**DEL WEBB AT MIREHAVEN PHASE 3 & 4  
 (TRACT M AND TRACT N-2-A-1, WATERSHED)**

Re: Del Webb at Mirehaven Phase 3&4 Grading and Drainage Plan and Drainage Report  
Engineers Stamp Dated: 05/10/2018 (H09D017G)

Enclosed are responses to the comments provided on June 19, 2018. Responses are listed in red below.

**KEYED NOTES**

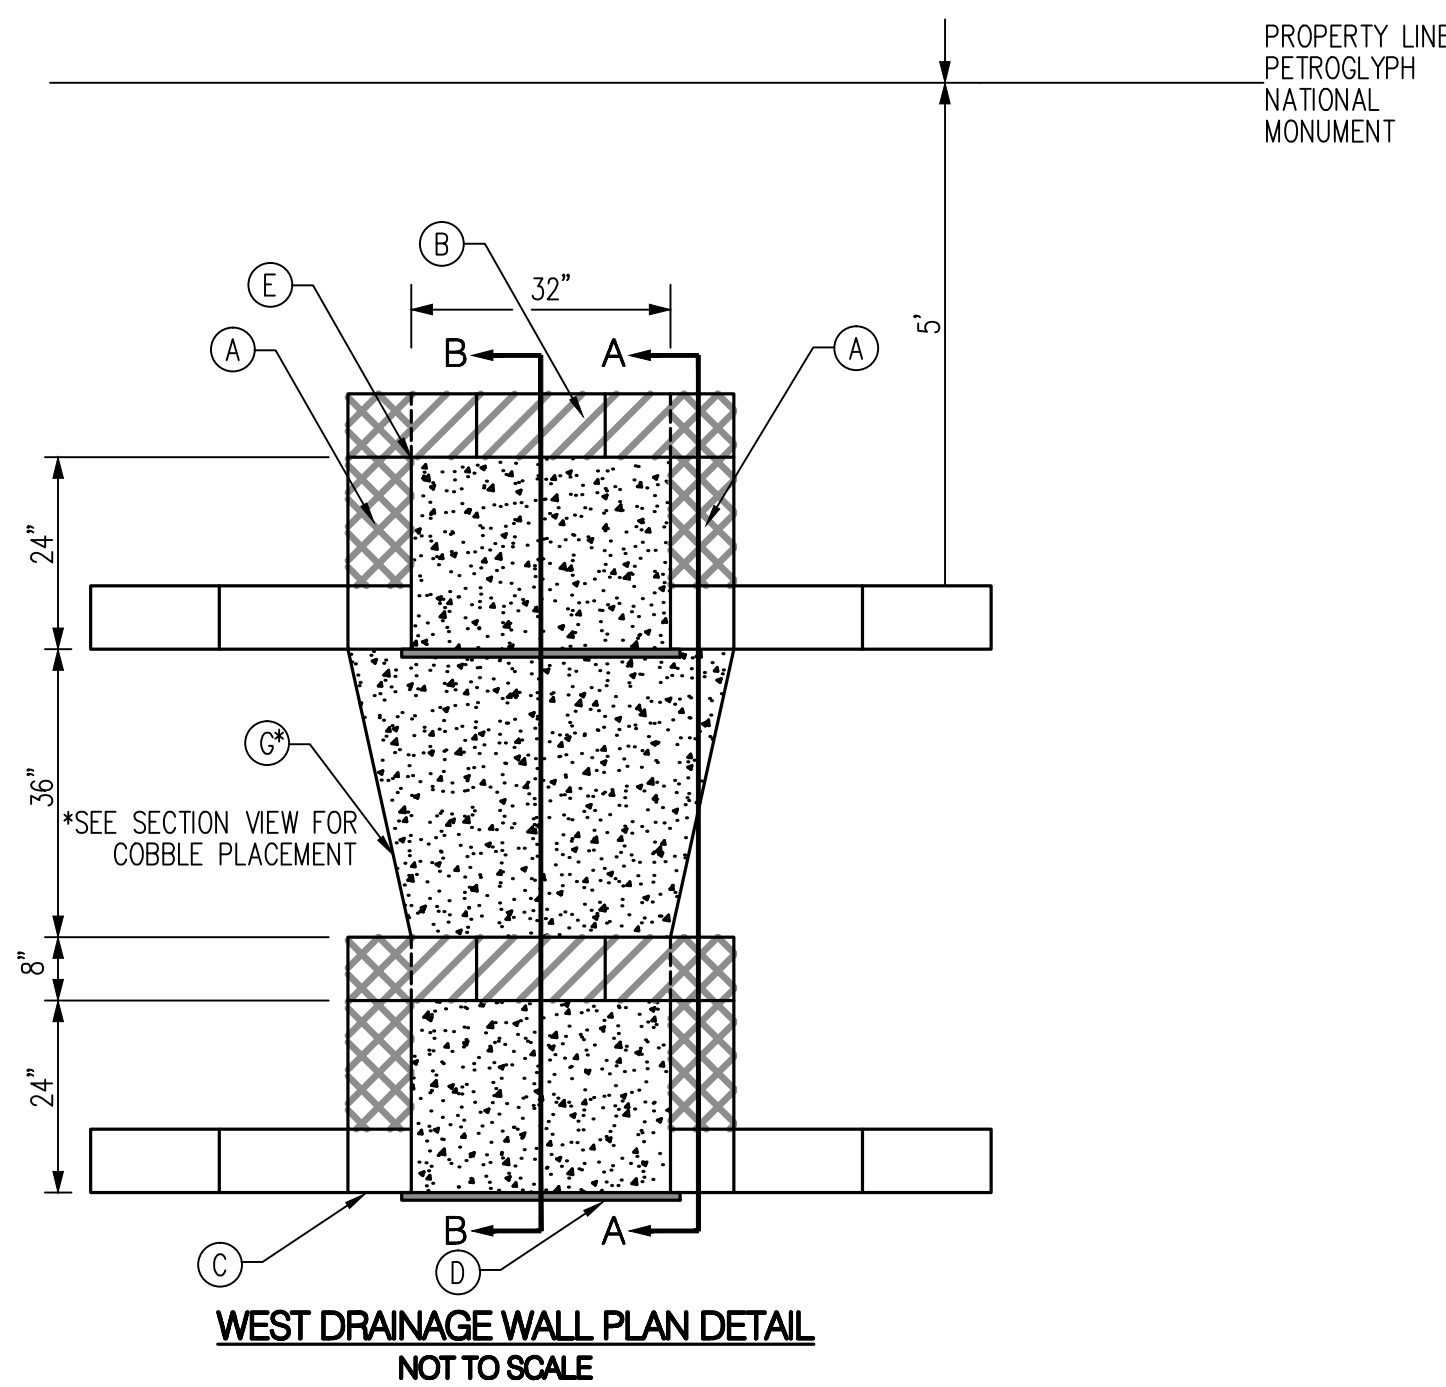
3. Change "North" to "West" on the detail sheets of concentrated flow paths down the steep slopes next to the National Monument. **This has been corrected.** Modify the detail to prevent runoff from flanking the drainage structure. **No modification necessary. A weir calculation is provided to show that the current design can handle of the offsite flow getting to each structure.** Show the property line on the detail. **This has been added** Also add a note to the contractor instructing him; "No disturbance is allowed on the monument, if damage occurs to neighbor's property then written acceptance of the repairs will be required prior to acceptance of Engineer's Certification. Contractor must

immediately stabilize the slope to prevent erosion from encroaching into the neighbor's property per details on sheet 4 of Unit 4 and sheet 6 of Unit 3".

Note has been added.

**POND VOLUMES LOTS 1-15:**

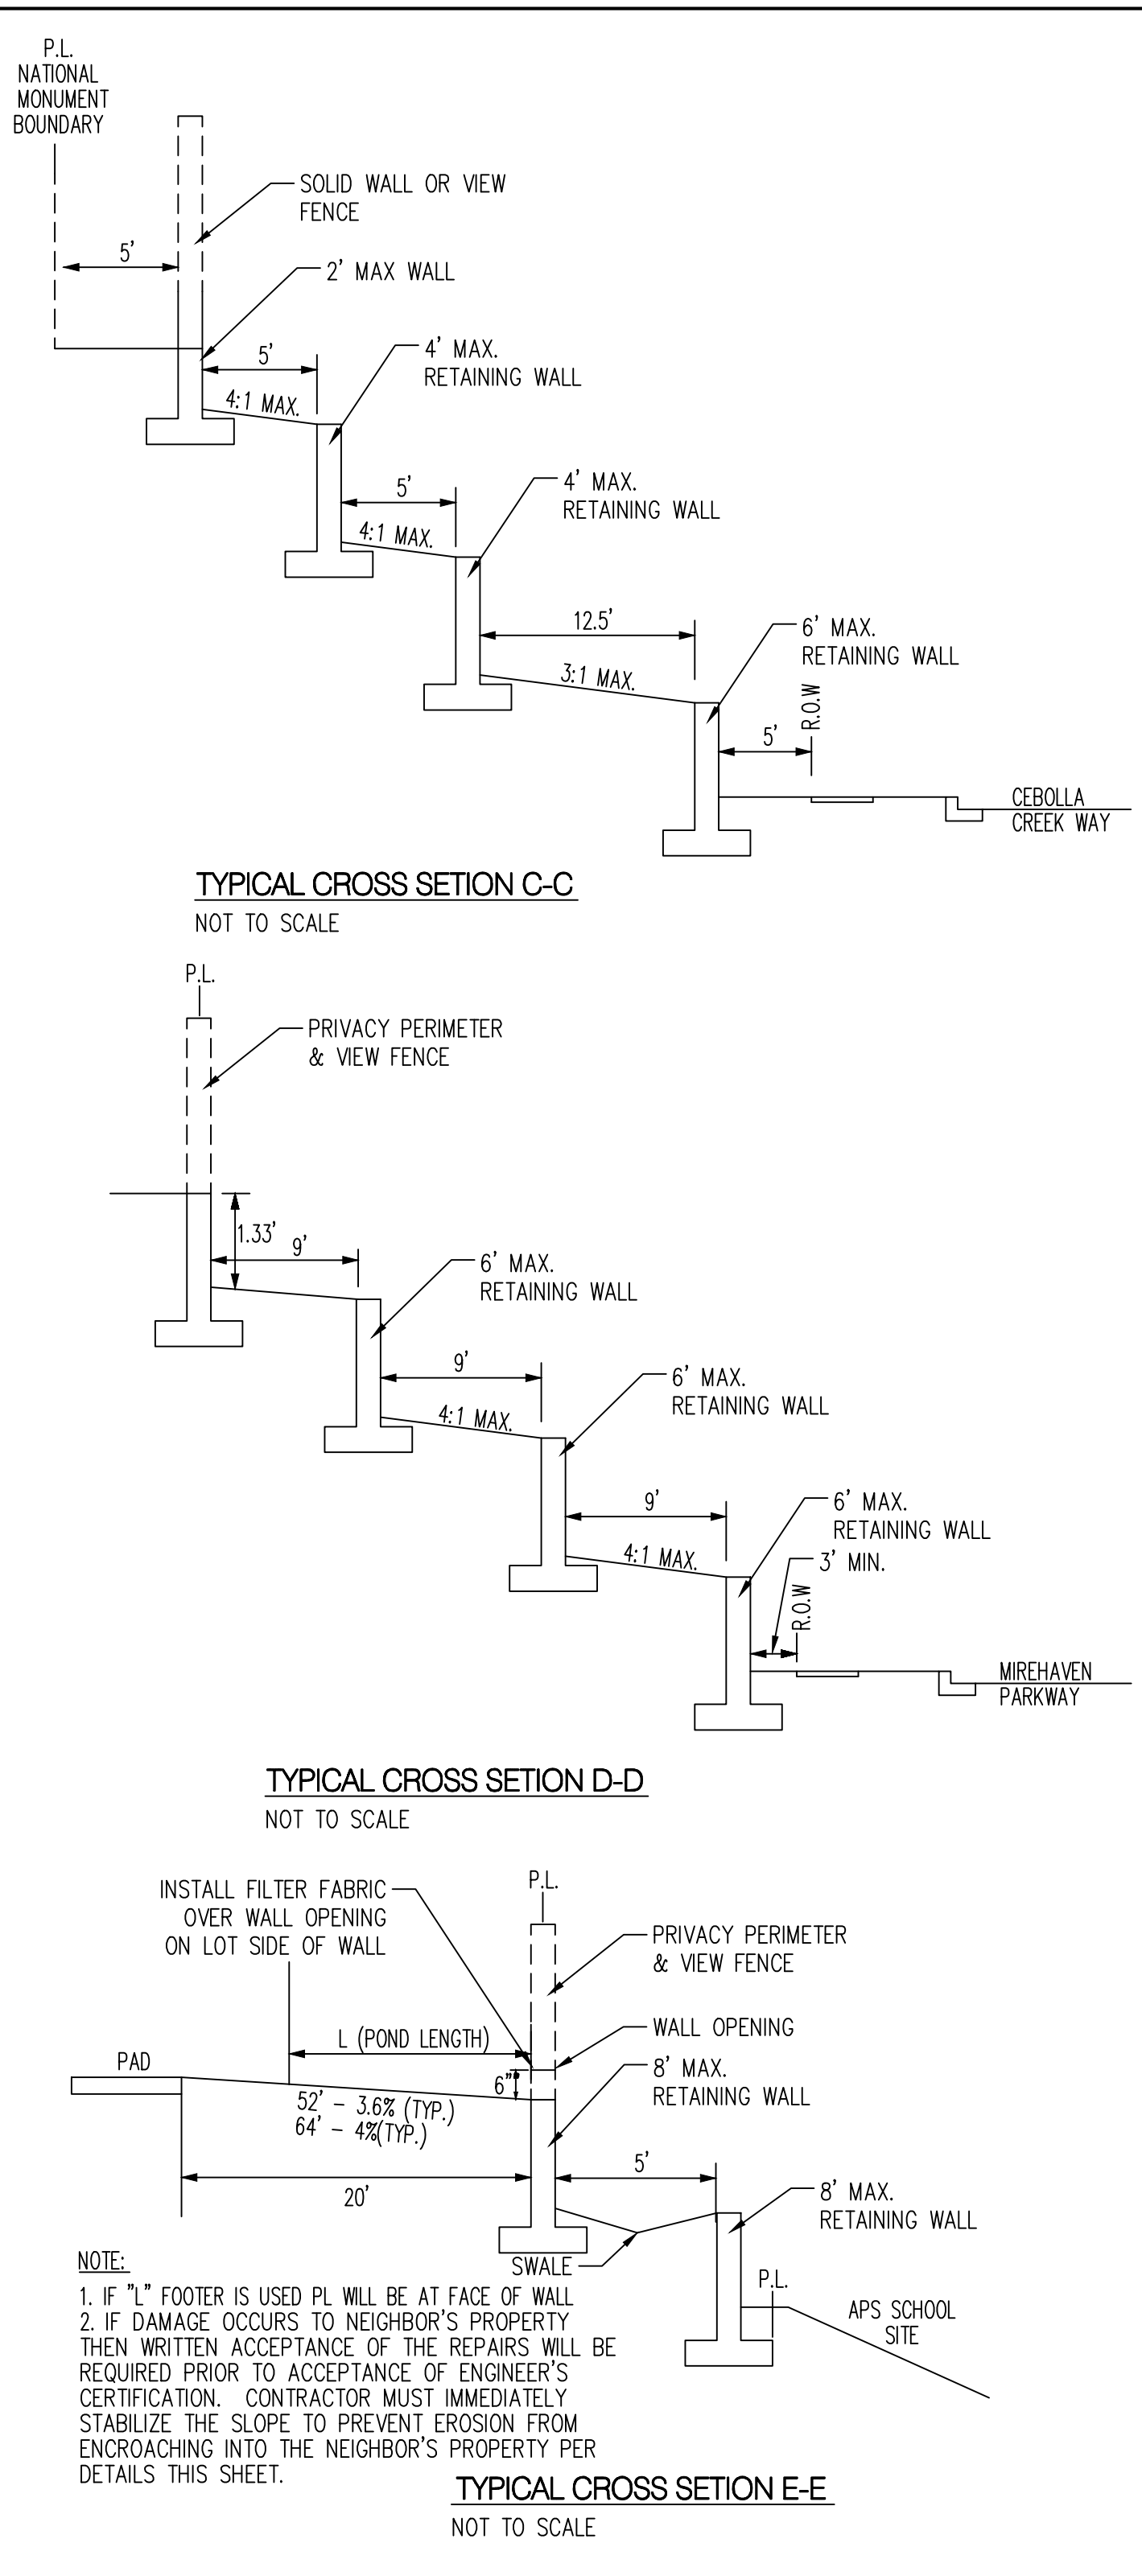
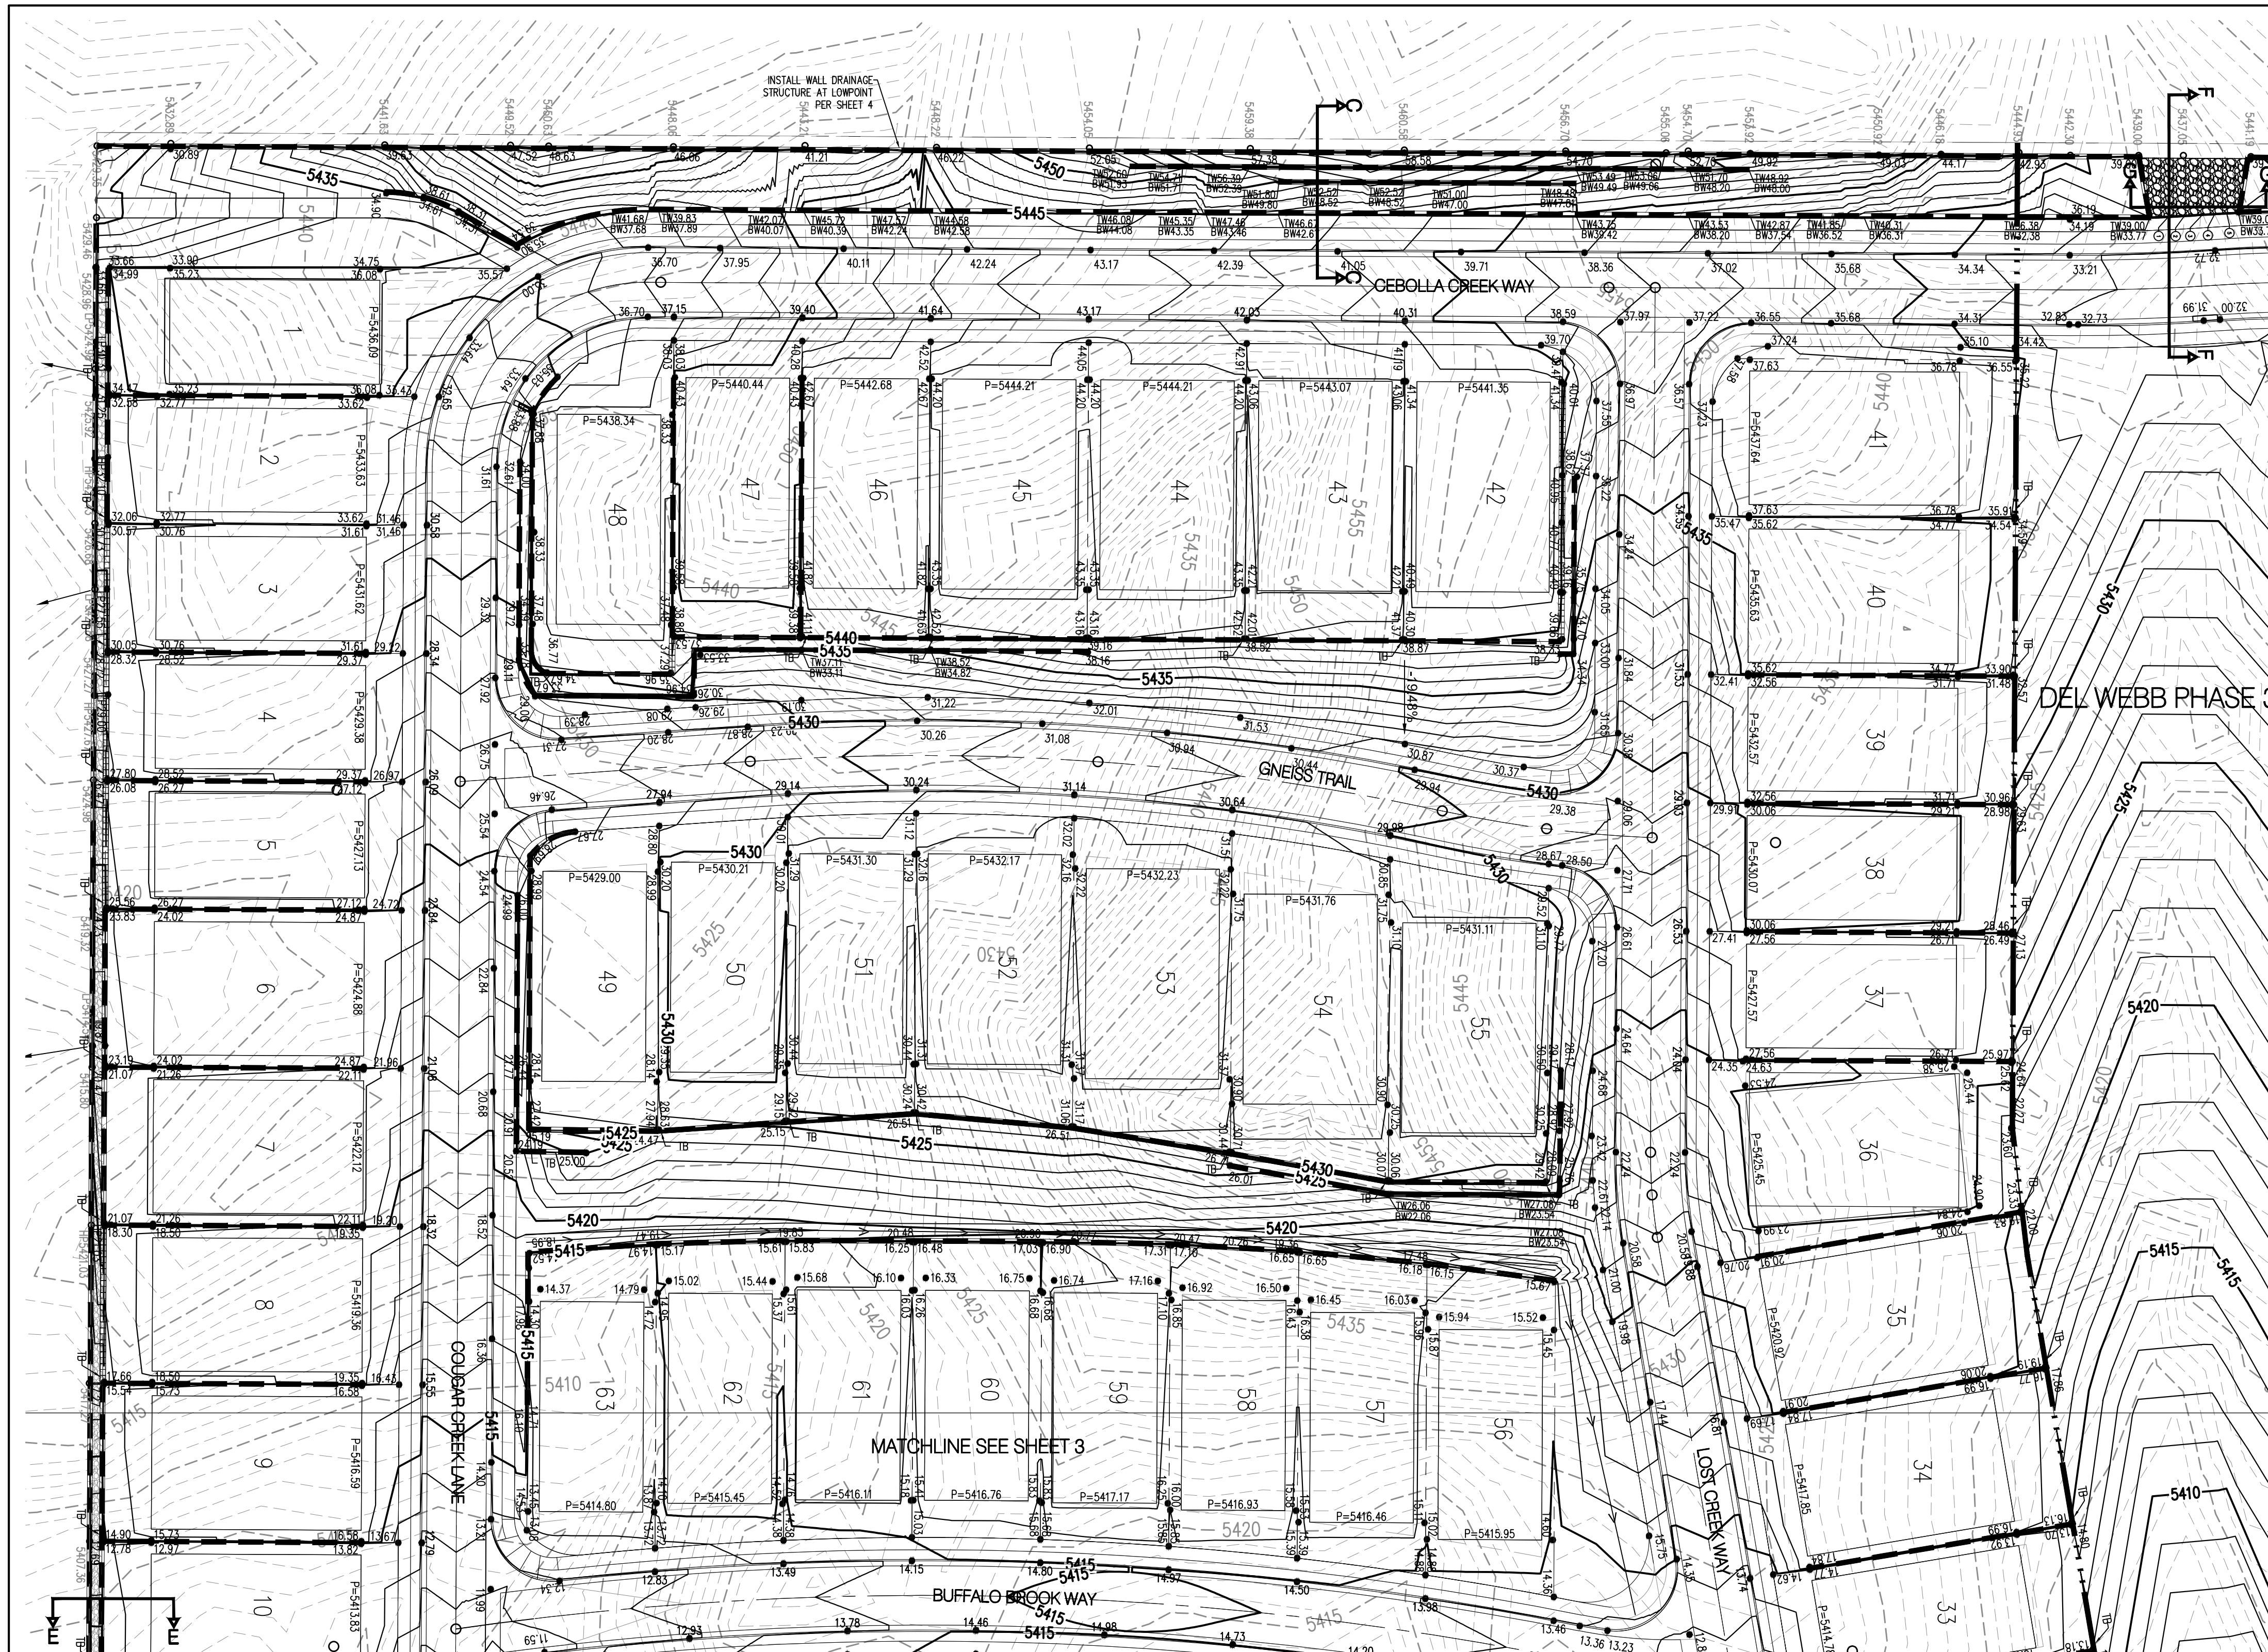
5. Add details of rear yard ponds along the south boundary next to APS to limit runoff from the 2 and 10 year storms to pre-developed rates. Treating the first flush is not enough. Typical Pond grading details, plan view and sections are required. As an alternative consider redesign to drain these lots to the street instead of onto the neighbor. New basin maps have been provided to show 2yr and 10yr runoff and volume for both the existing and proposed basins draining to the APS site. Details and tables have been added to the Unit 4 grading plan to show the volume needed to be retained for the 2YR storm. For both the 10yr and 100yr the developed runoff and volume is less than existing. Cross-section E-E shows the volume storage based on needing a 6" high turned block needed to retain the difference in the developed vs existing runoff for the 2yr storm.
